GOVERNMENT OF INDIA  
MINISTRY OF ENVIRONMENT & FORESTS  
**Central Zoo Authority**

**Sub:- Construction of enclosures for Common leopard, Clouded leopard and Wild boar at Biological Park, Itanagar.**

The design for the construction of enclosures for Common leopard, Clouded leopard and Wild boar at Biological Park, Itanagar were placed before the Meeting of the Expert Group on Zoo Designing of the Central Zoo Authority held on 12<sup>th</sup> December, 2011. The observations of the committee are given below:-

**PROPOSED ENCLOSURE  
FOR CLOUDED LEOPARD AT BIOLOGICAL PARK, ITANAGAR**

DRWG NO : WLS/CDL/04

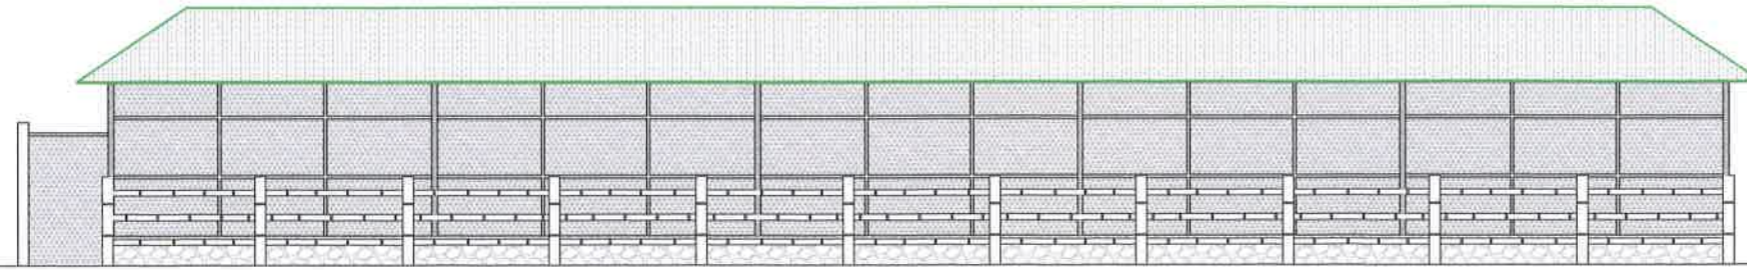
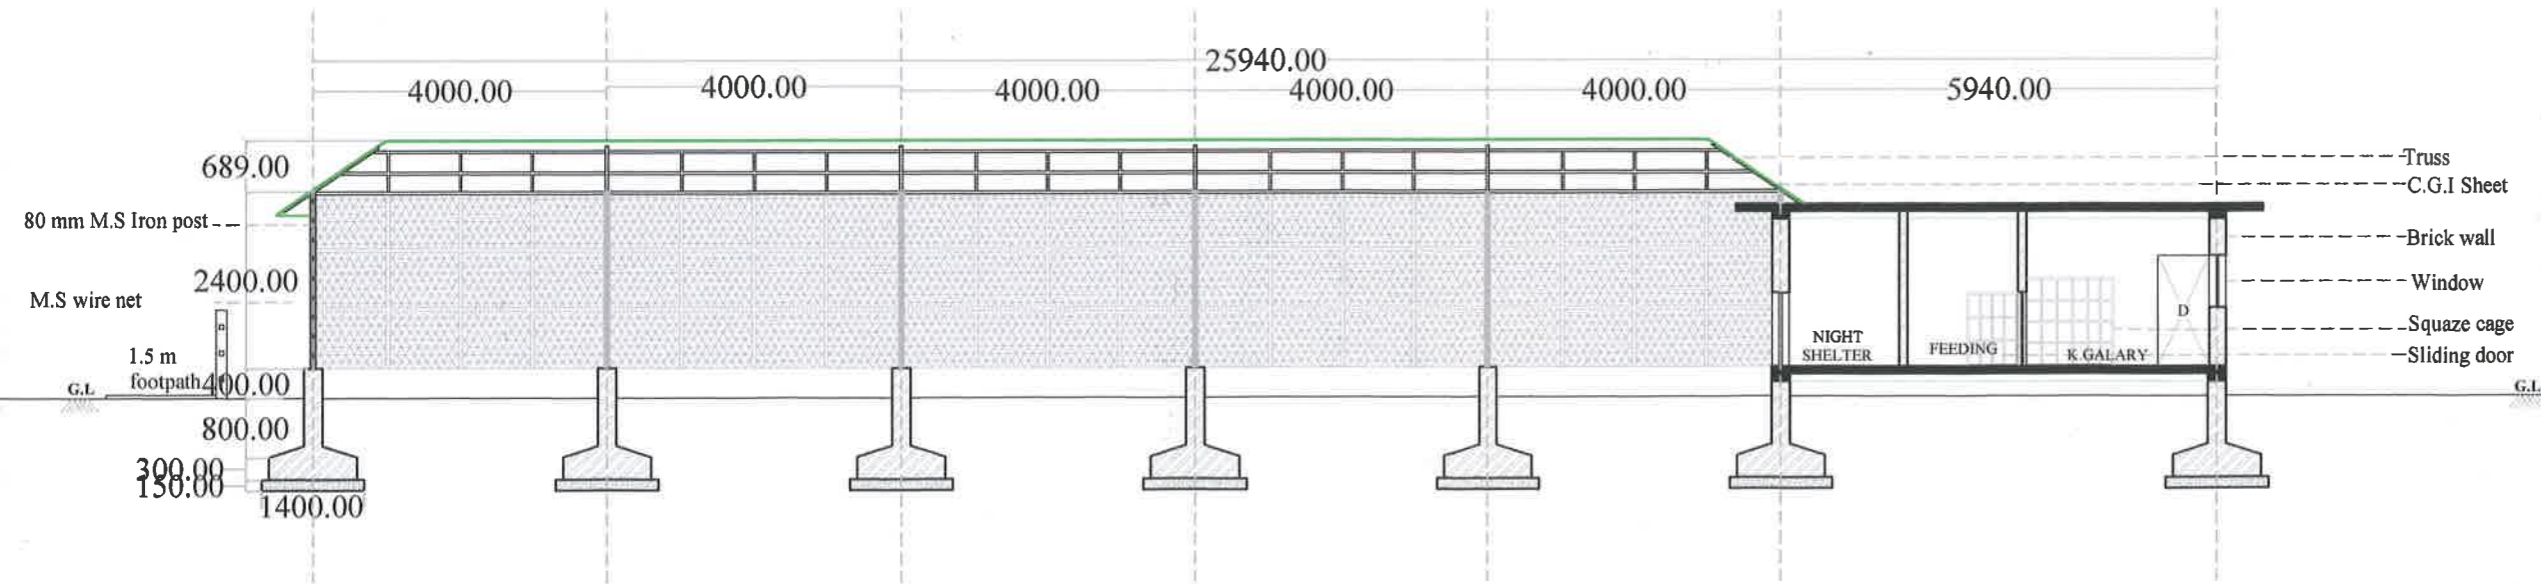
- a. The paddock area preferably should be in rectangular shape subject to the availability of land. The ratio of paddocks length-width should be of atleast 2:3.
- b. The housing facility for animals should have atleast six numbers of feeding and retiring cells, which should be located in such a way flushing towards paddock area in horizontal manner along the contour. The one side of feeding cell should have a provision of a squeeze cage.
- c. There should be a keeper gallery of 2 meter wide. The keeper's gallery should have opening on both sides.
- d. The feeding and retiring cells should be interlinked with partition using sliding doors.
- e. The feeding and retiring cells should be located of atleast 2 meter high from the ground level with a provision of proper drainage system.

Keeping in view of the above, revised design should be submitted to the Central Zoo Authority for records. A copy of the design indicating the necessary changes may also be forward to the Zoo Director for carrying out necessary amendments.
